Addendum No.2

Date: December 16, 2022
Project: Sea Island Circle Beach Access Amenity Improvements (2022-SL03)
LJA Project No. C275-21181

C7

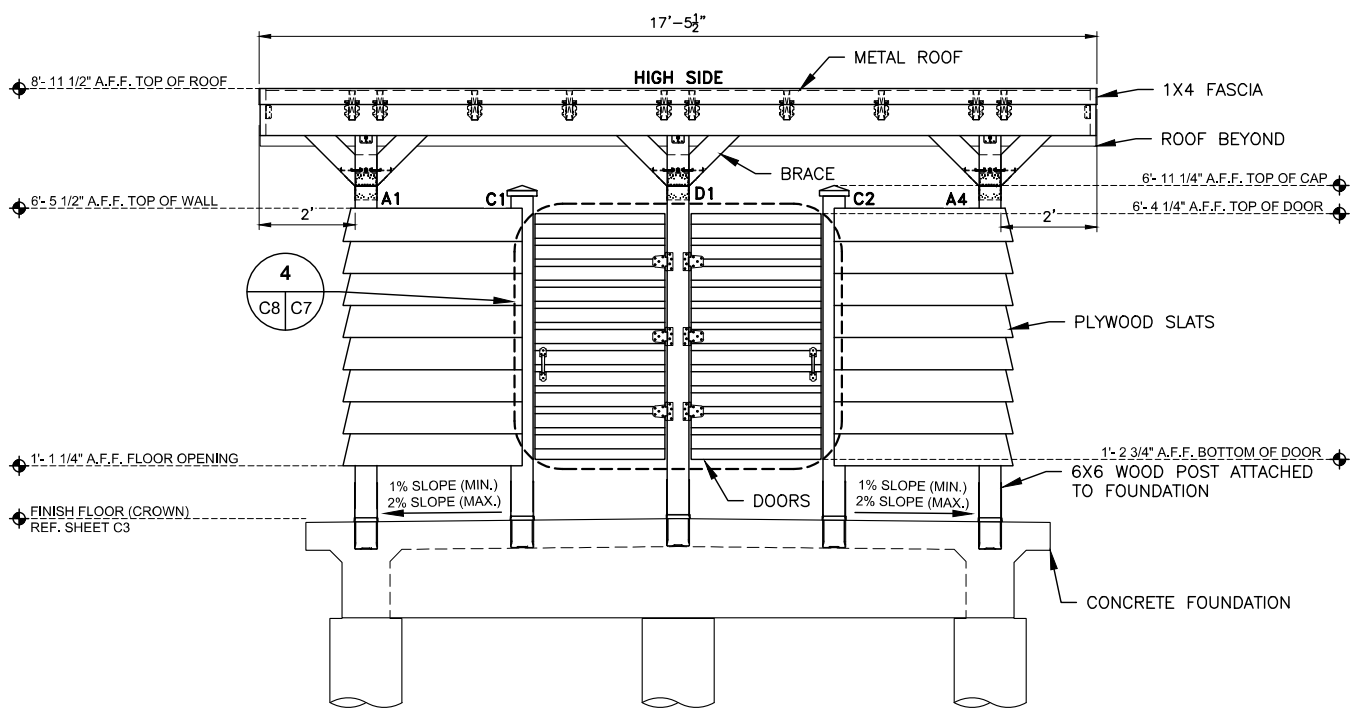
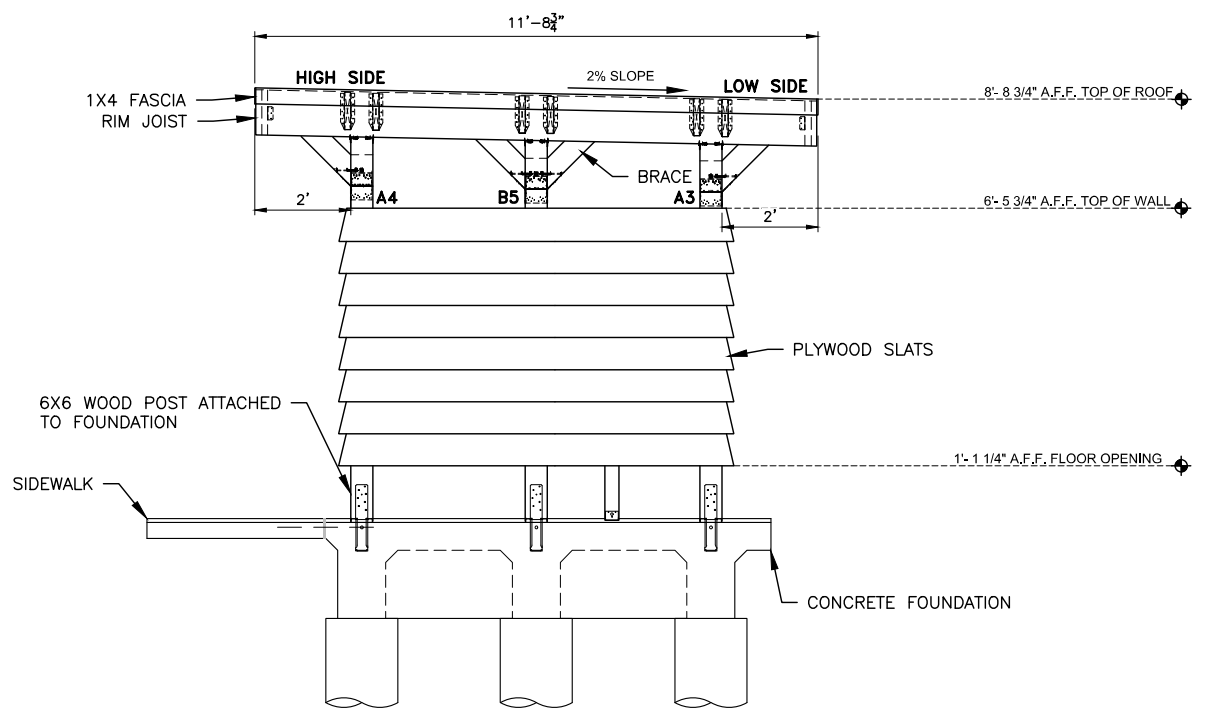
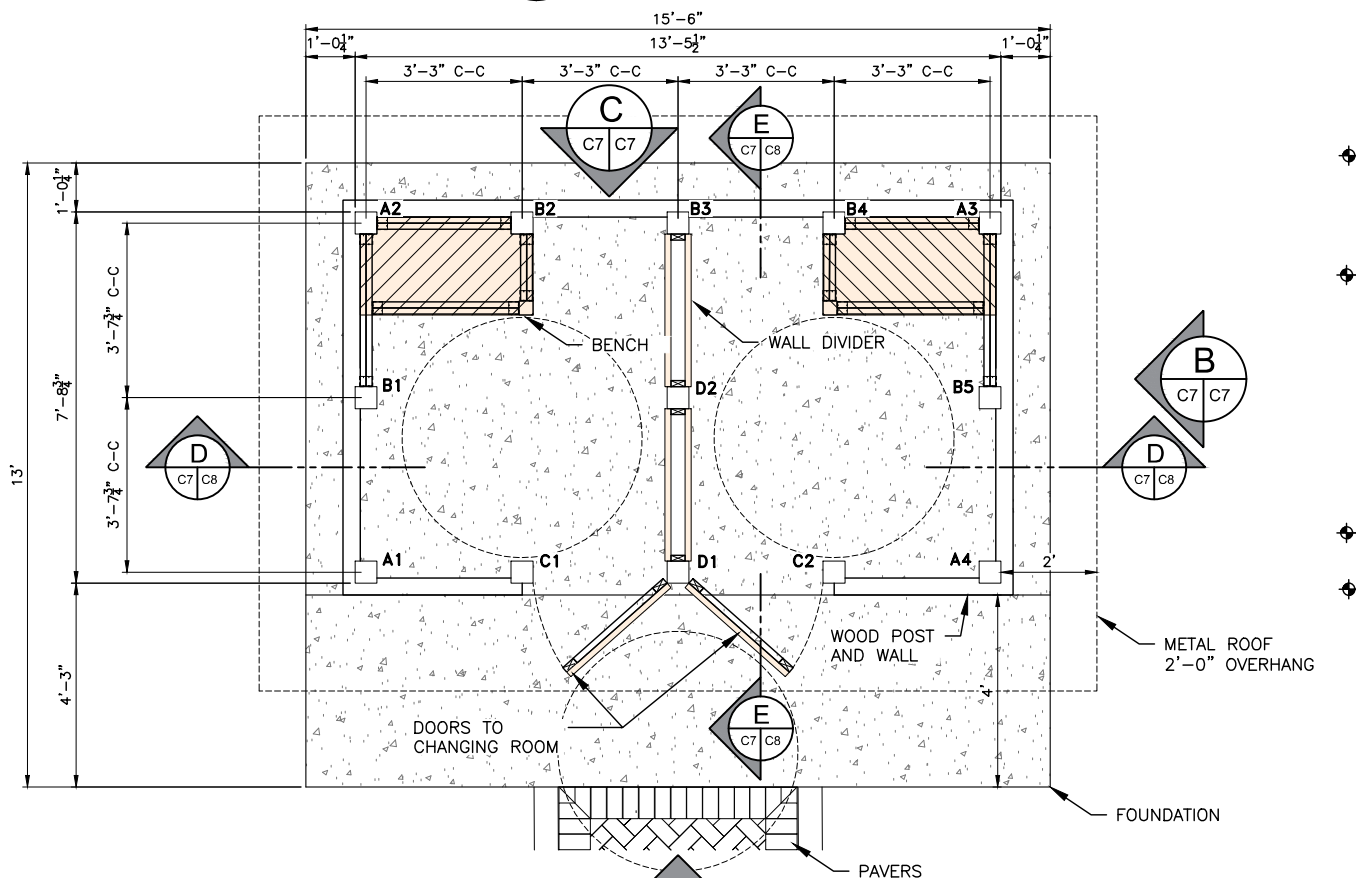
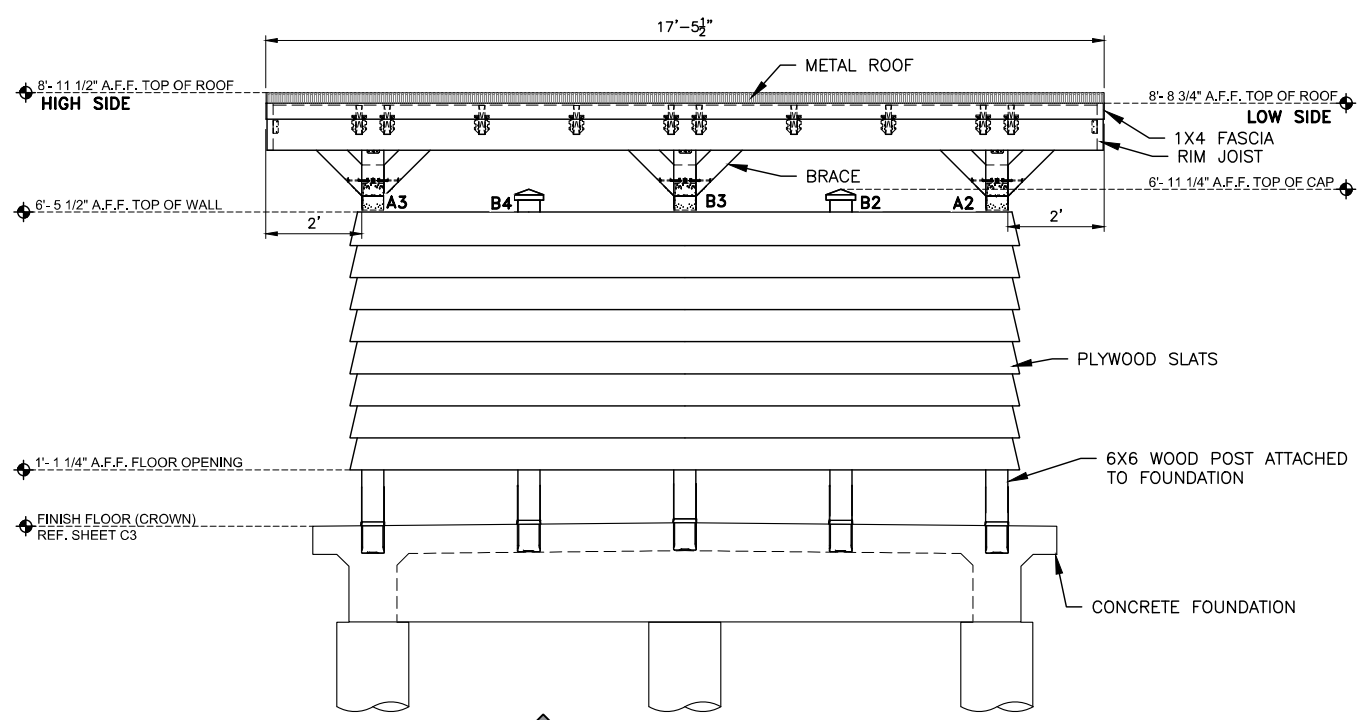
REVISION NO.	DATE	DESCRIPTION
1	12/16/2022	REVISED BENCH DESIGN AND OVER ALL BUILDING DIMENSIONS

C10

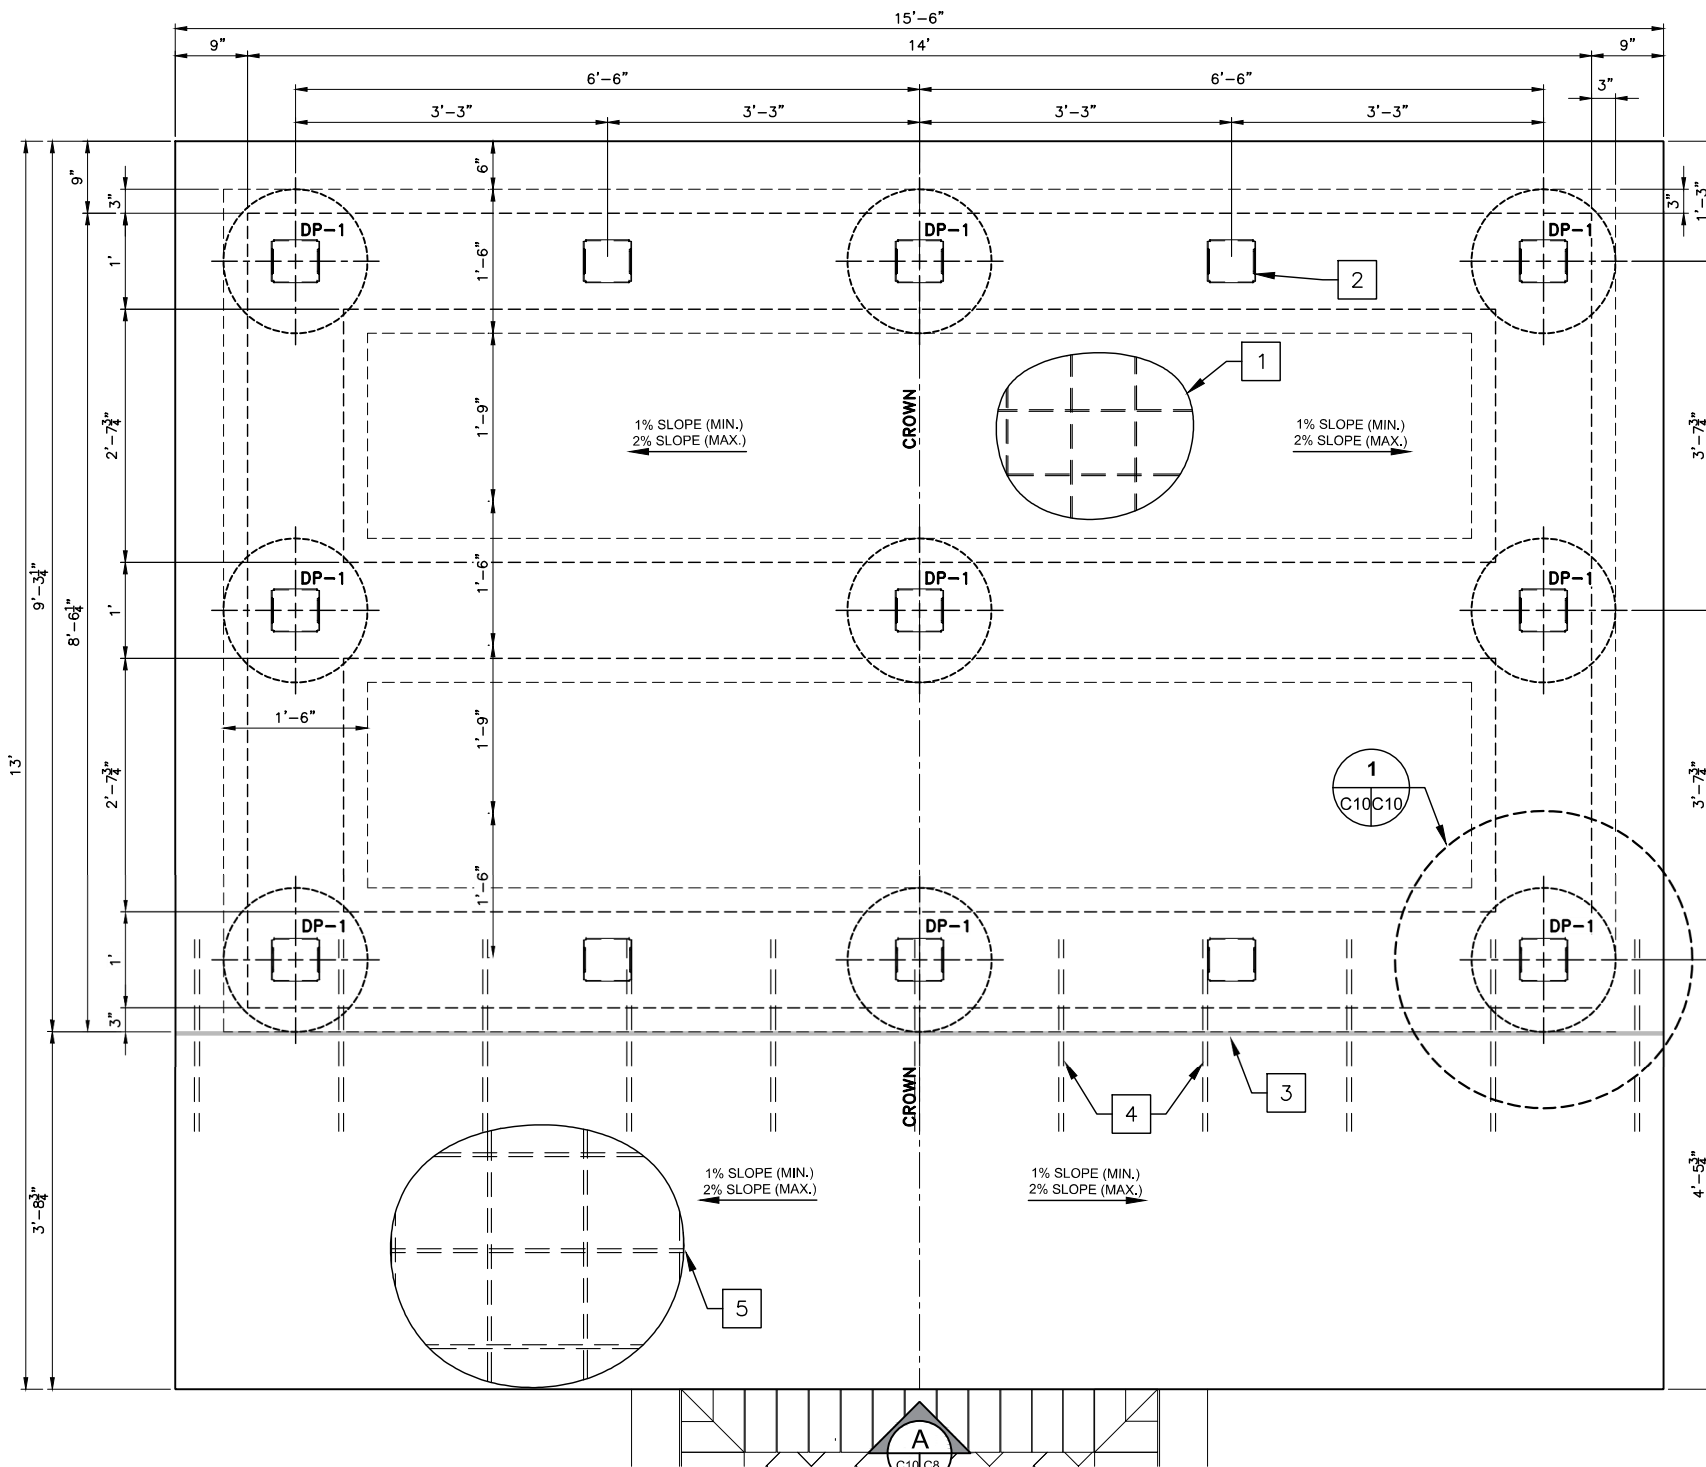
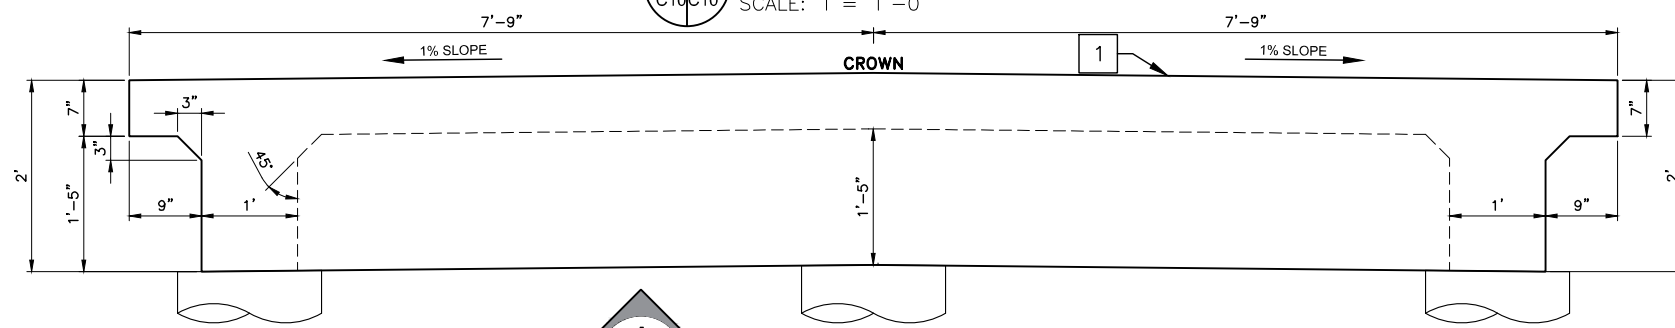
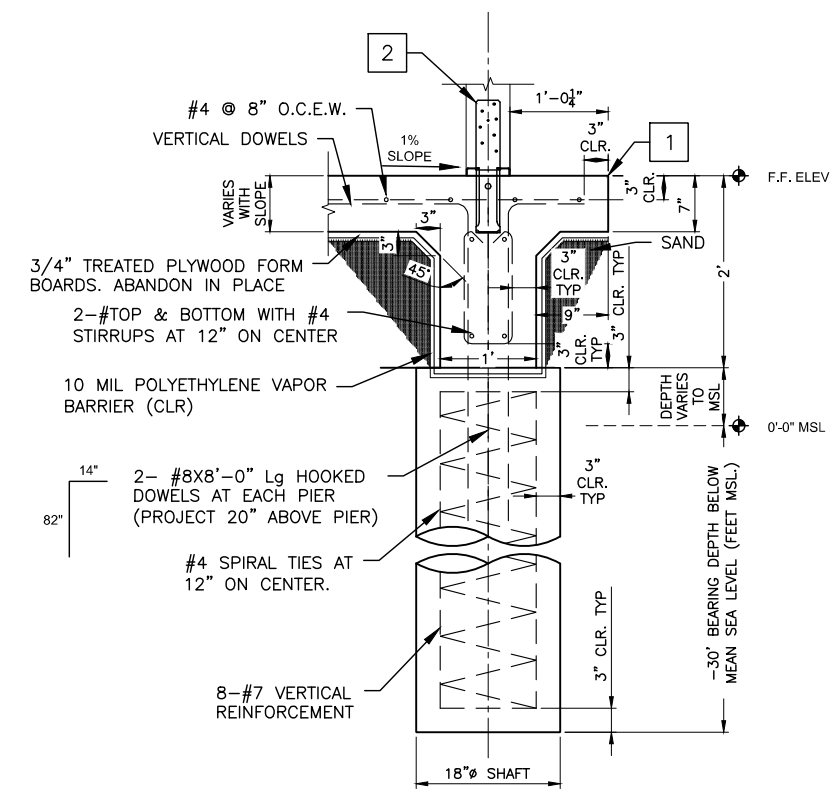
REVISION NO.	DATE	DESCRIPTION
1	12/16/2022	REVISED OVER ALL DIMENSION
